DUNE Near Detector Cavern Size Update

KLOE's size is better defined

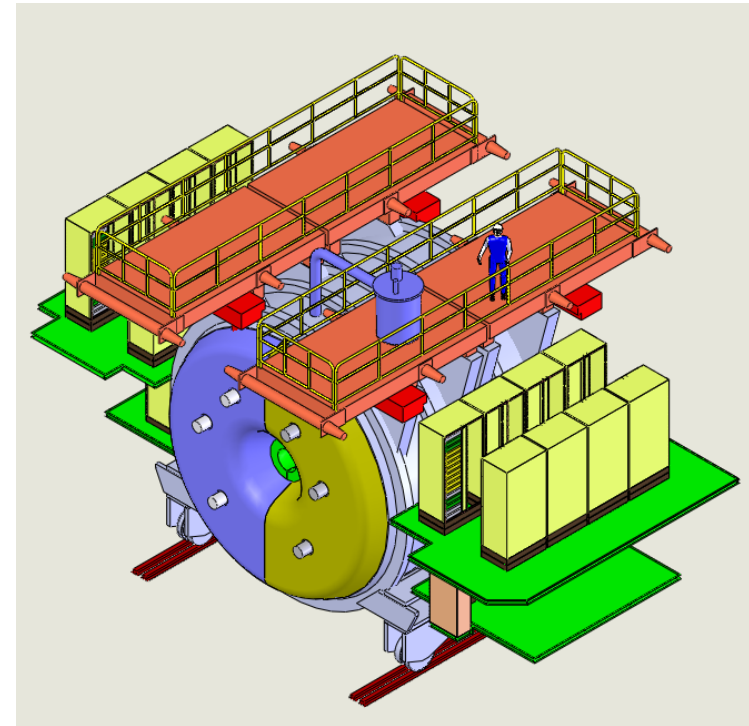
KLOE grew in size.

We now have a much better understanding on how large the supporting equipment and electronics really are

The Alcove needs to grow significantly to accept all of the hardware

Cavern size constraint

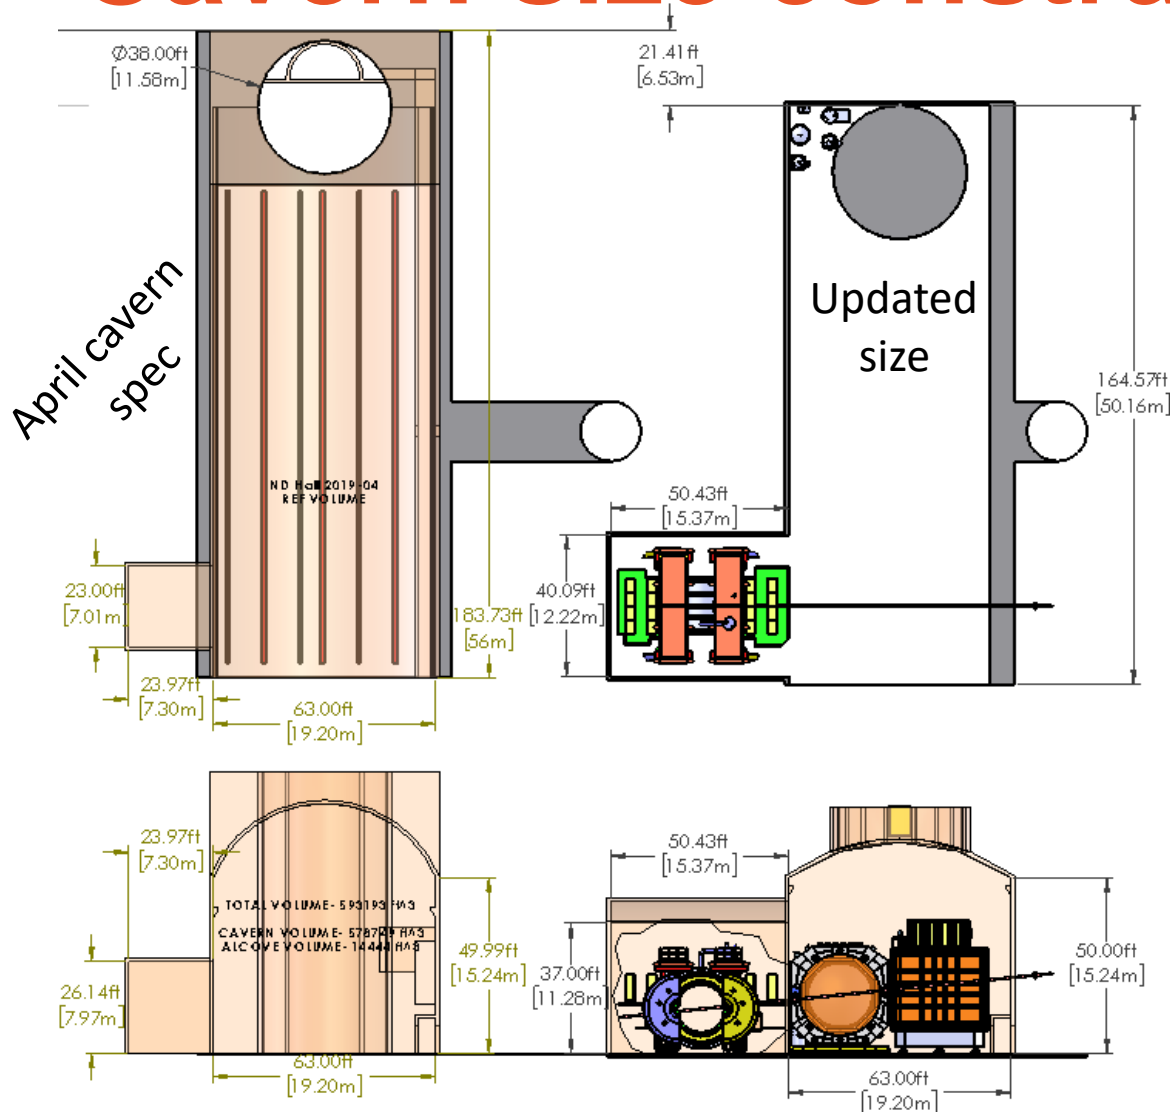
The volume of the cavern is currently constrained to the April 2019 spec.
(The volume does not include the arched ceiling)

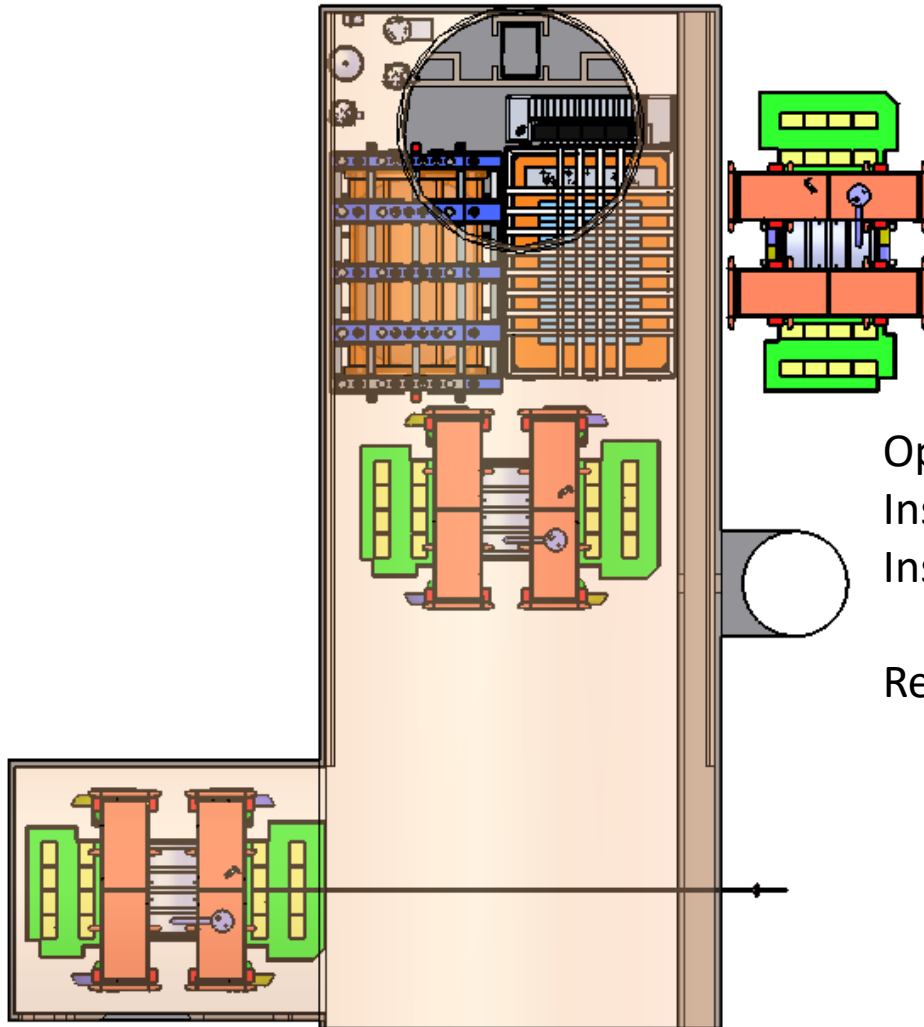
To maintain the same volume, the hall was shortened approx. 22 ft.

Detector assembly is performed under the vertical shaft. Crane capacity is currently limited to 15 tons.

A 15 ton crane above KLOE is desired - availability TBD.
